## **INFORMATION LETTER 407-00-55**

**SUBJECT: AIR CONDITIONER COMPRESSOR DRIVE PULLEY**

**Service Bulletin:** SB407-101; Bell 407 Air Conditioner Compressor Drive Pulley.

**Subject:** Inspection & Torquing Procedure for the Air Conditioner Compressor Drive Pulley Installation.

Figure 1 Compressor Drive Pulley Installation Details

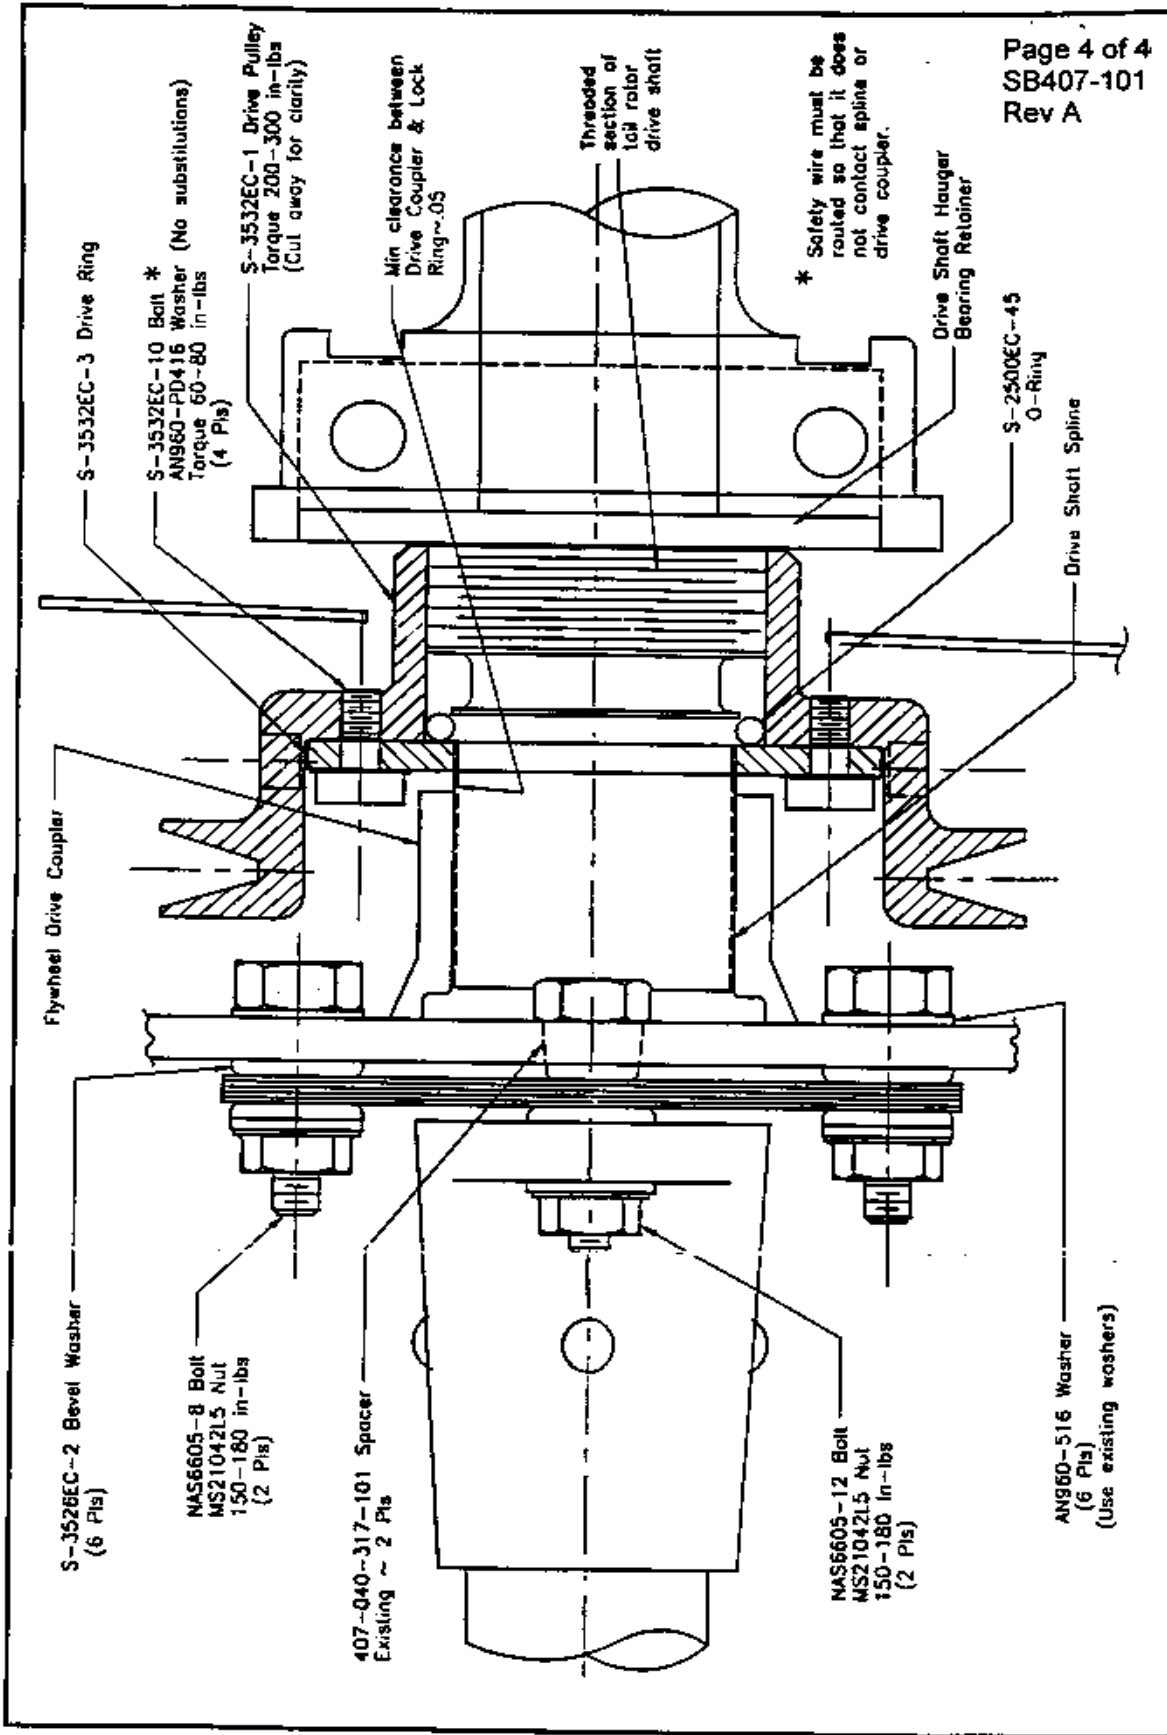
It has come to our attention that excessive driveshaft spline wear may occur if the Compressor Drive Pulley is not properly installed.

This wear may occur at the Drive Ring Spline interface. To prevent wear in this area during operation the Drive Pulley must not rotate relative to the thread on the shaft.

Wear of the Compressor Drive Ring Spline and Compressor Drive Pulley Threads is caused by insufficient torque, or improper torquing procedures when installing the Compressor Drive Pulley (P/N S-3532EC-1).

2. Install Compressor Drive Pulley and Drive Ring as follows.
  - a. Install the Compressor Drive Pulley (P/N S-3532EC-1) on the forward end of the Tail Rotor Driveshaft, thread the pulley tightly against the face of the Driveshaft Hanger Bearing Retainer.
  - b. Torque Compressor Drive Pulley to 200 – 300 in lbs., using a .257 Dia X .13 Deep Spanner wrench, utilizing one of the four available holes on the pulley body. (See note page 3 of 4).
  - c. Install the Drive Ring (P/N S-3532EC-3) on the Driveshaft Spline, and slide into place. Align four of the twelve holes provided in the drive ring with the four threaded holes in the Compressor Drive Pulley.

Alignment of the four holes in the Drive Ring to match those in the Compressor Drive Pulley is accomplished by a “trial and error” method of placing the Drive Ring on the Driveshaft spline to check for hole alignment. Several rotations of the Drive Ring may be necessary to achieve the desired hole alignment. If rotation of the Pulley is required to achieve the Drive Ring hole alignment, the pulley torque must be increased. Do not exceed 350 in lbs of torque.

- d. Once the correct hole alignment is achieved between the Drive Ring and the Compressor Drive Pulley, Install the four retaining Bolts (P/N S-3532EC-10) and Washers (P/N AN960-PD416) torque to 60 – 80 in lbs., and safety the bolts in pairs using .032 safety wire.

- e. Install Flywheel Drive Coupler, Flywheel and existing Drive Shaft mounting hardware as shown on Page 4 of 4, torque nuts to 150 –180 in lbs.

Minimum clearance between the Flywheel Drive Coupler, and the Drive Ring is .050 inch.
